Location of Construction: 1636 Washington Ave Owner Address:	Owner: <b>Printy, Craig</b> Lessee/Buyer's Name:	Phone: Business Name:
Contractor Name: Jeffrey R. Verrill	Address: 12 Baston Rd No. Yarmouth, ME 04097	Phone: 829-6005
Past Use: 1-fam	Proposed Use: Same w/addition	PERMIT FEE: \$ 15,000.00 INSPECTION: Use Group: Type:
Proposed Project Description: Construct Addition (23 x 28)		
Permit Taken By: Mary Gresik	Date Applied For: 20 August 1997

RE: 1636 Washington Avenue 348-C-059

CHECK-LIST AGAINST ZONING ORDINANCE

Site Sketch  
 Zone = R3  
 Total Lot Area = 10,500 ft<sup>2</sup>  
 Area Covered by Structures = 1,508 ft<sup>2</sup>

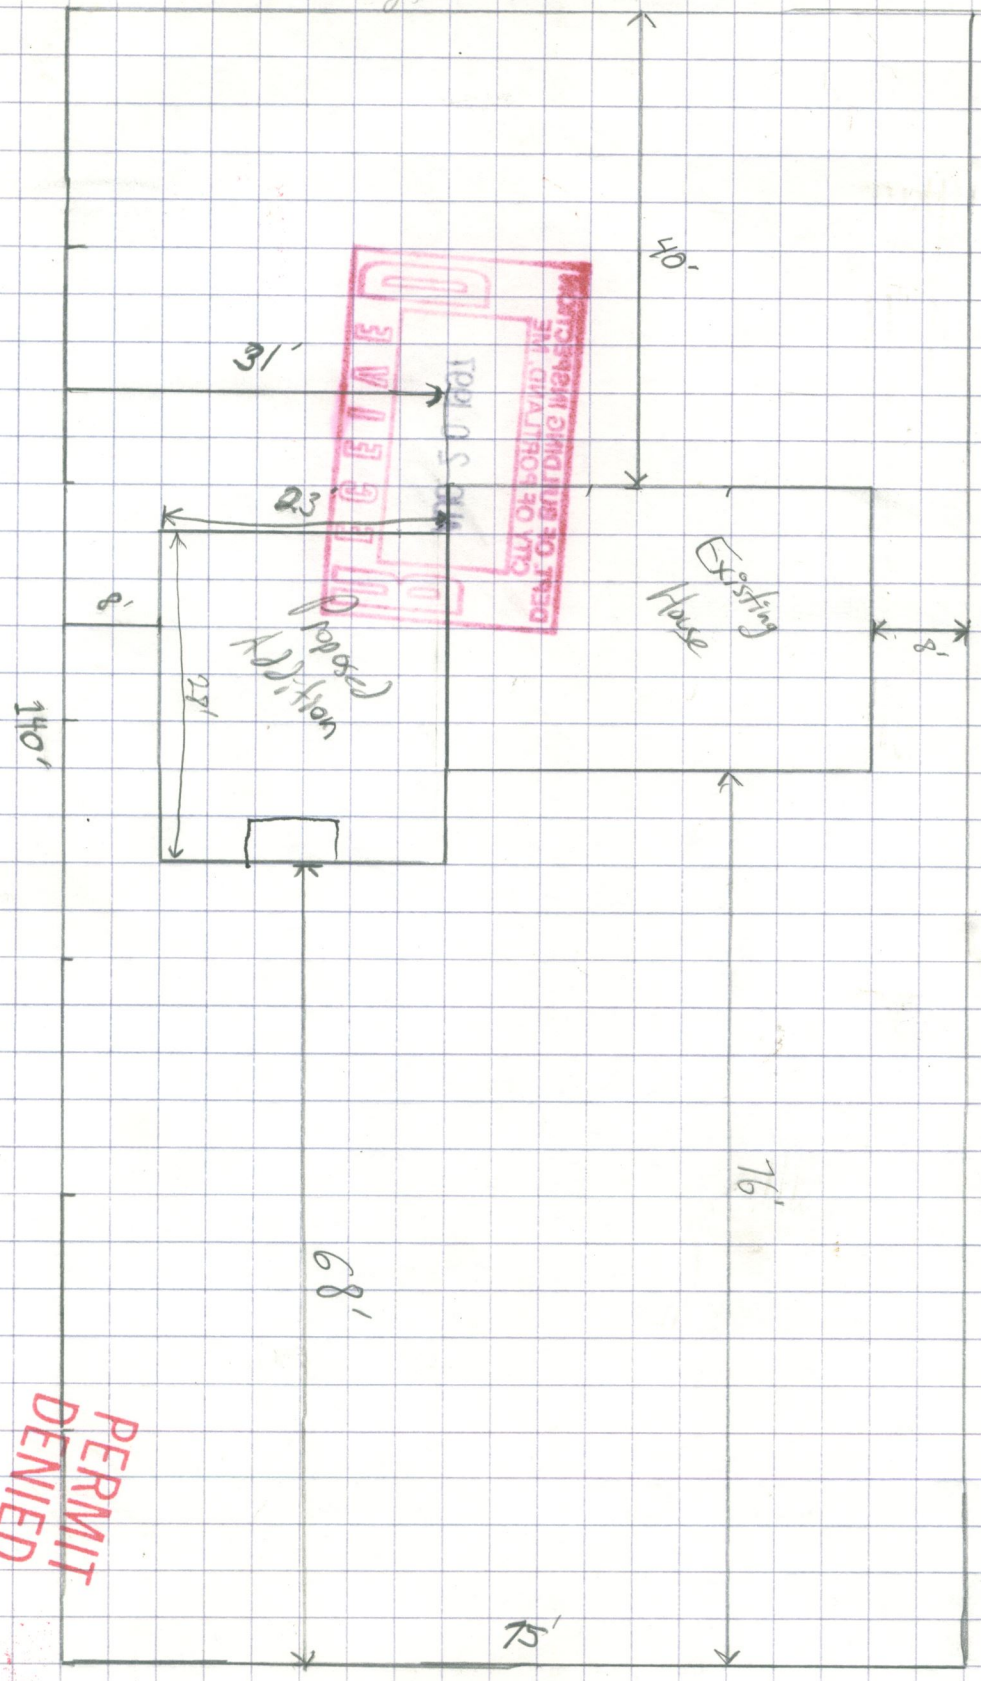
Denied: 14' setback  
 Required instead of  
 9' show

not allowed

→ Side Yard - 14' req - 8' shown
